UNITED STATES PATENT AND TRADEMARK OFFICE

APPLICATION NO.	FILING DATE	FIRST NAMED INVENTOR	ATTORNEY DOCKET NO.	CONFIRMATION NO.
10/788,788	02/26/2004	Michel Grandjean	040215-000000US	6142

Office Action Summary

FINAL OFFICE ACTION

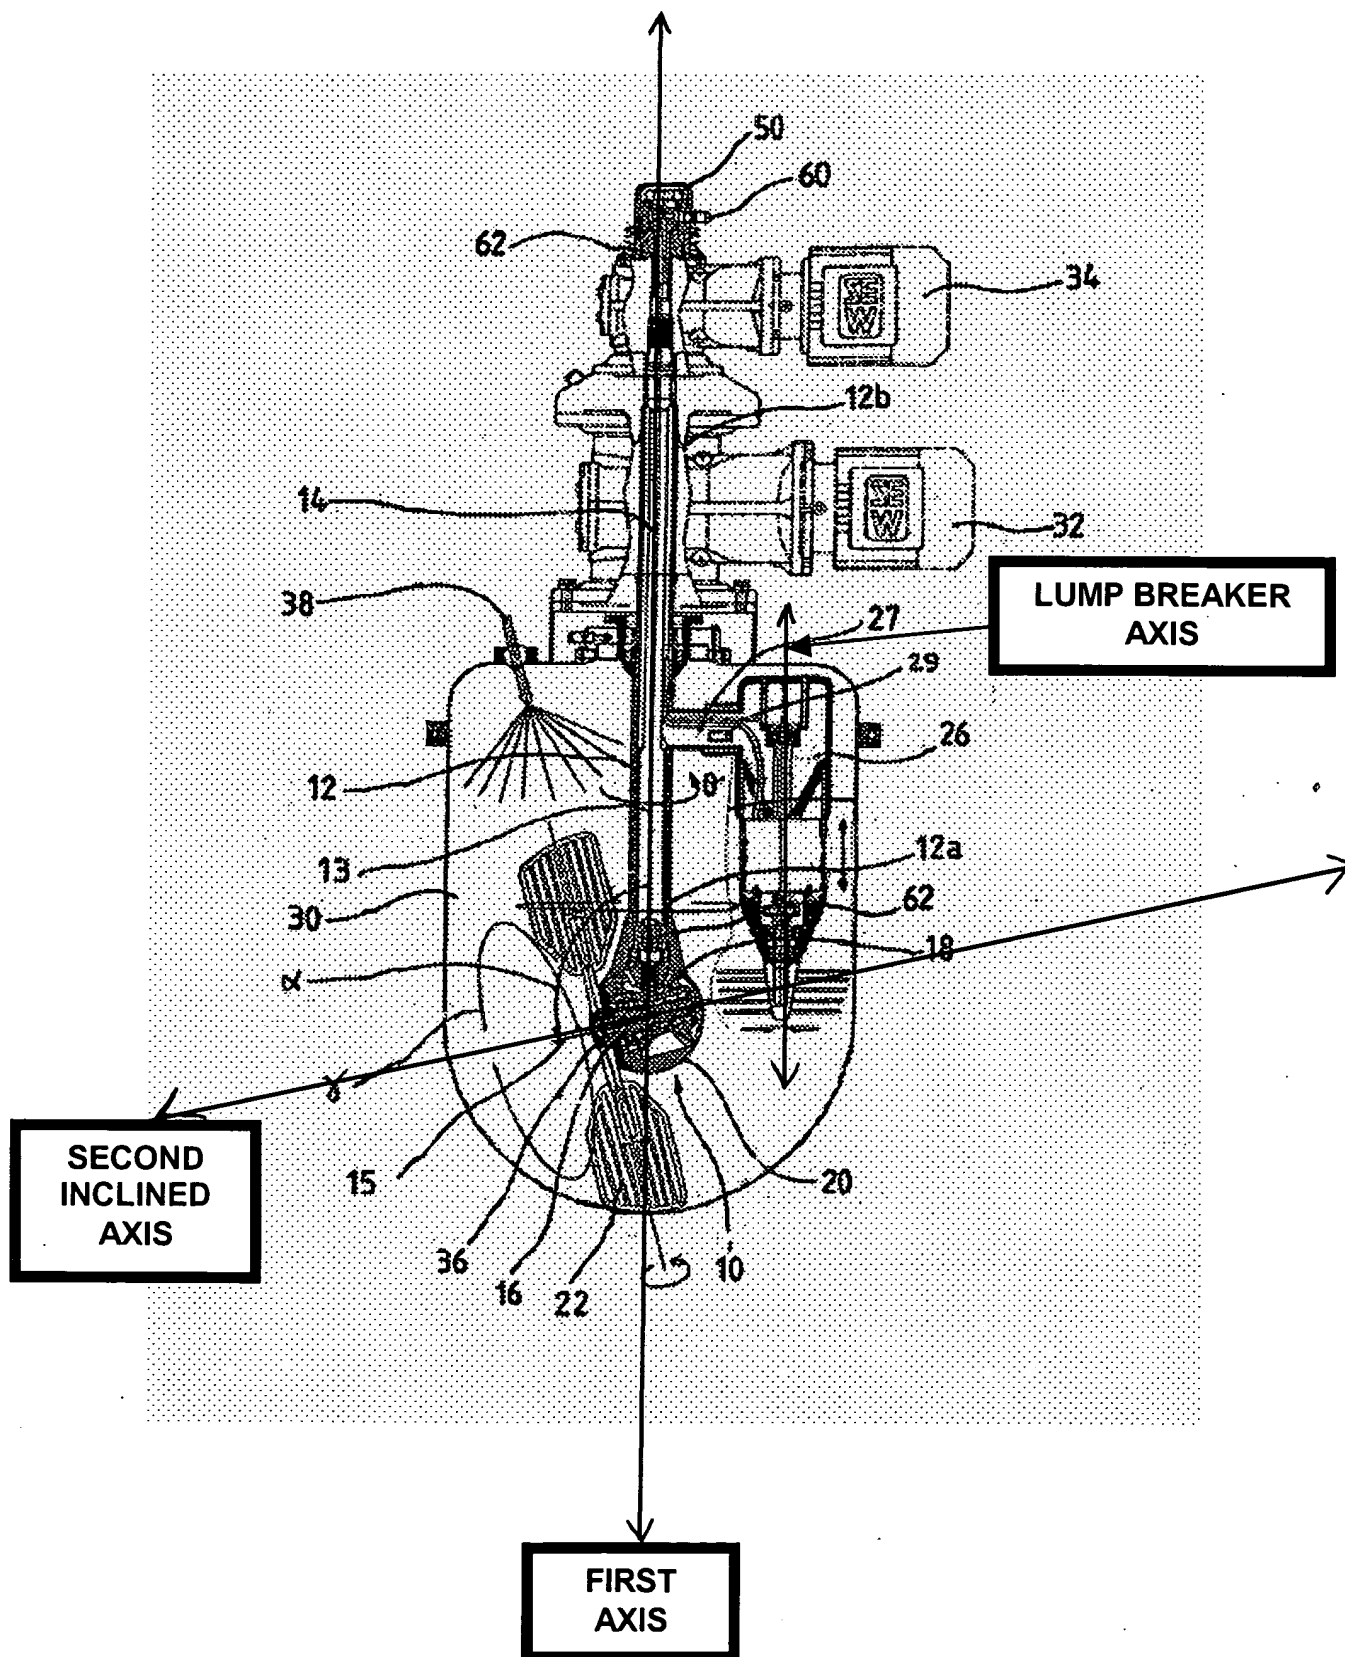
a. Contrary to Applicant's assertions, the subject matter of claim 15 remains not shown. In Figure 2 that Applicant refers to, the lump breaker 26 is shown along an axis oriented parallel to the first axis or an axis that intersects the second inclined axis (as defined by claim 1) but not along the inclined second axis. See the depiction below that reinforces this objection.

Claim 15 appears technically inaccurate. As noted and depicted above, the lump breaker 26 is shown along an axis oriented parallel to the first axis or an axis that intersects the second inclined axis (as defined by claim 1) but not along the inclined second axis. See the depiction below that reinforces this objection.

Correction is required.
